Release Note

Edgecore EWS5203 Release v3.52.0100

Document # Edgecore_EWS5203_ERN_v3.52.0100

Enhancement from v3.52.0001

2.2 Support WiFi6 QoS

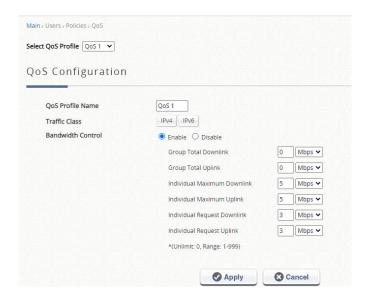
The QoS feature can be supported in WiFi6 AP like EAP101 and EAP102.

With split tunnel SSID, only Individual maximum downlink/uplink are supported.

With complete tunnel SSID, Group total downlink/uplink, Individual maximum downlink/uplink, and individual request downlink/uplink are supported.

2.4 Add Download Button in Management Event Download

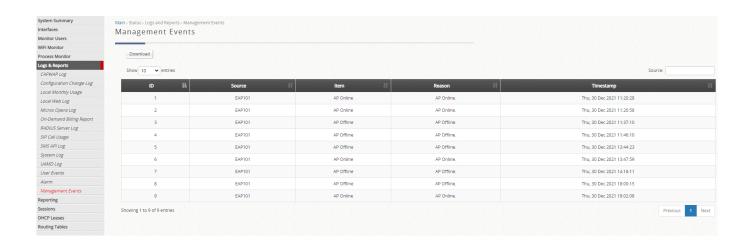
In Status > Logs & Reports > Management Events page, the download button is added. After clicking the button, the management event report will be written in the txt file and be downloaded into the device.

2.5 Modify Method to Security Method in New Generation WAPM template

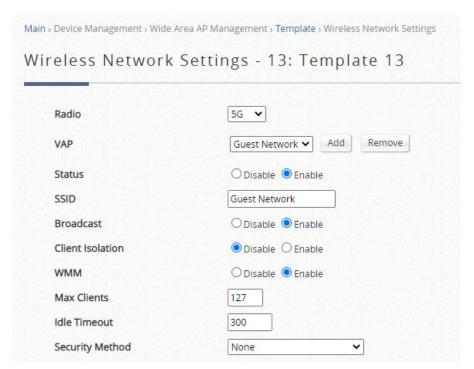
In Device > WAPM > Template page, modify the name from Method to Security Method in the Wireless Network.

2.6 Modify the Name of WAPM Template

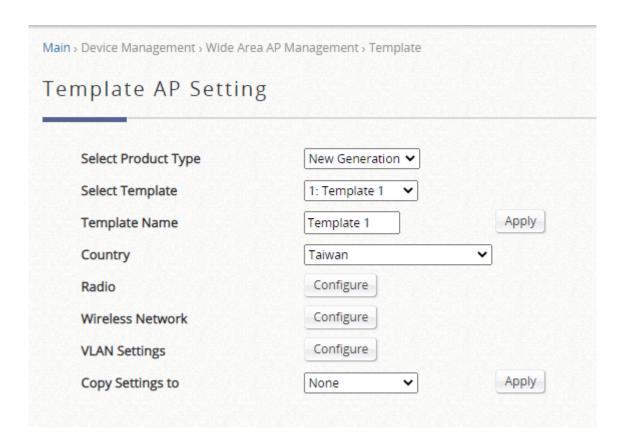
In Device > WAPM > Template page, modify from WiFi5 to Legacy and WiFi6 to New Generation in the Select Product Type.

Legacy devices supported: OAP100, OAP100e, EAP100, ECW100, ECW5210-L, ECW5211-L, ECW5410-L, ECW05210-L, ECW05211-L, ECW05213-L

New Generation devices supported: EAP101, EAP102, SP-W2M-AC1200

1. HA Mode – standby controller

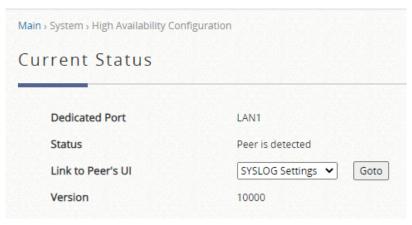
In System > High Availability page, SYSLOG Settings page can be supported in standby controller when HA is established. Syslog can be stored into the USB storage when plugging into the USB port of standby controller.

2. HA Mode – active controller

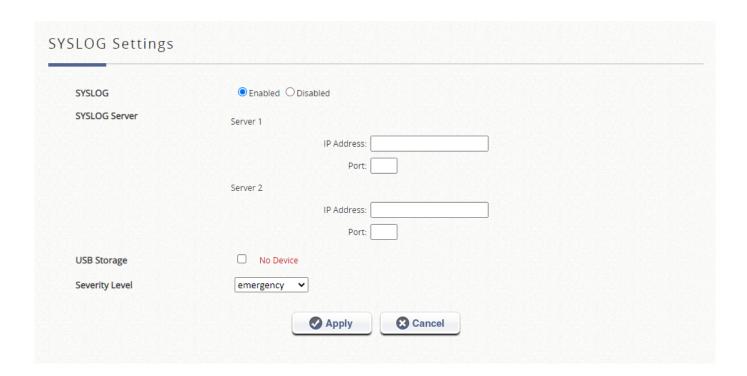
Syslog can be stored into the USB storage when plugging into the USB port of active controller.

3. Non-HA Mode

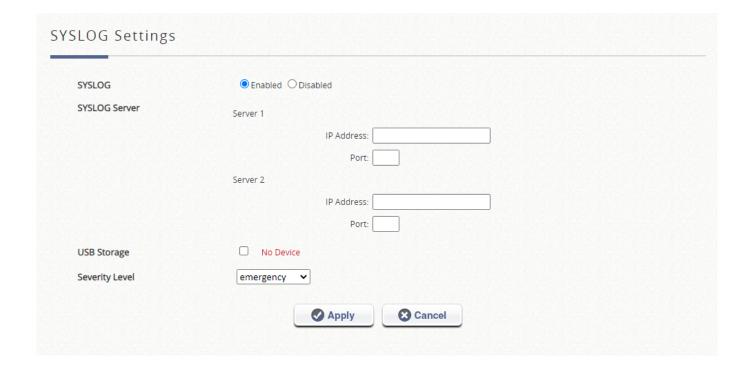
Syslog can be stored into the USB storage when plugging into the USB port of controller.

2.9 Support Import AP List

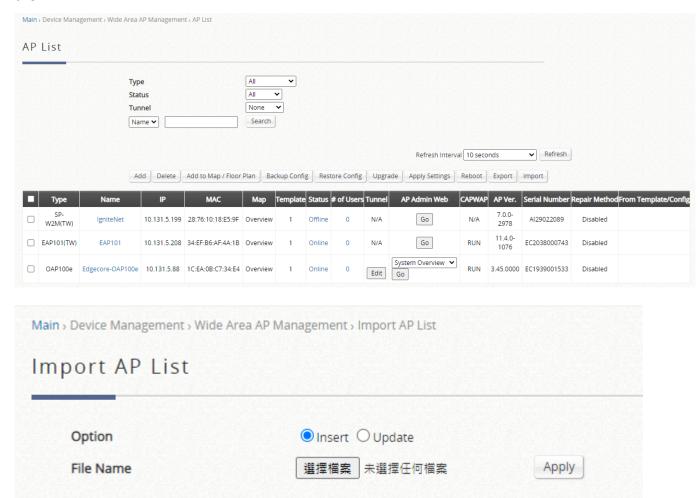
In the Device > Wide Area AP Management> AP list, add import button to import the csv file. After importing the list including default template, AP can apply the default template when adding the AP into the WAPM.

2.10 Support HA WAN Failover

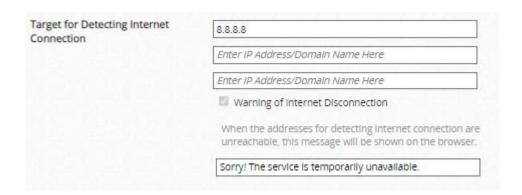
In System > WAN page, enter IP address or domain name in the "Target for detecting Internet connection" of WAN traffic settings. Set up the HA peer. WAN HA failover mechanism will be enabled to switch HA when WAN1 fails to ping IP address or domain name.

Note: Only WAN1 is connecting to the Internet. If WAN1 fails to ping each IP address or domain name in the above list, HA will be triggered.

4. When WAN detection is enabled, all WANs are down. The local system log will receive the message below:

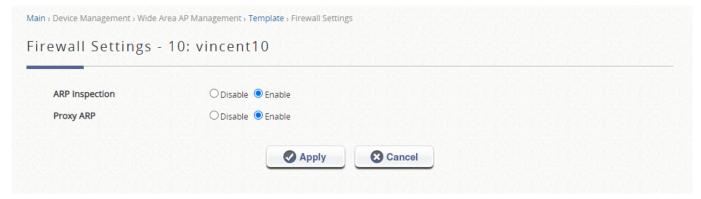
root: WAN FAIL

2.15 Support Midtrans Payment Gateway

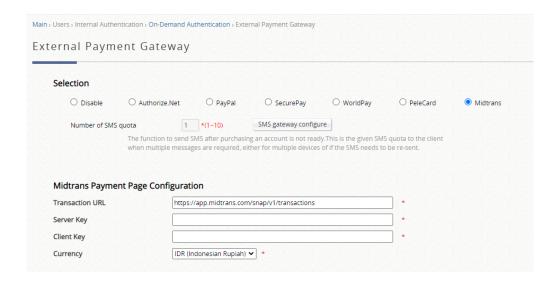
In Users > Internal Authentication > On-Demand > Payment Gateway, Midtrans option is added in the external payment gateway option. The On-demand account will be created after buying a new account online through Midtrans payment.

2.16 Support Work from Home Mode for SP-W2M-AC1200

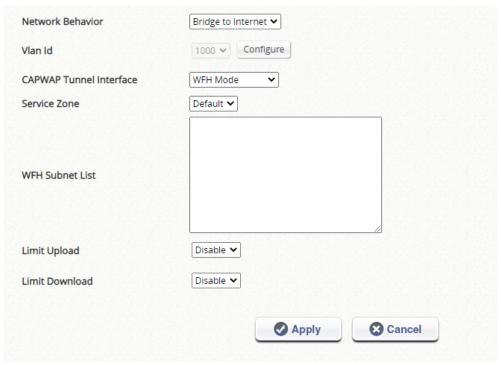
In Device > WAPM > New Generation Template > Wireless Network, add WFH (Work from home) mode in the CAPWAP Tunnel Interface. This feature is only compatible with SP-W2M-AC1200.
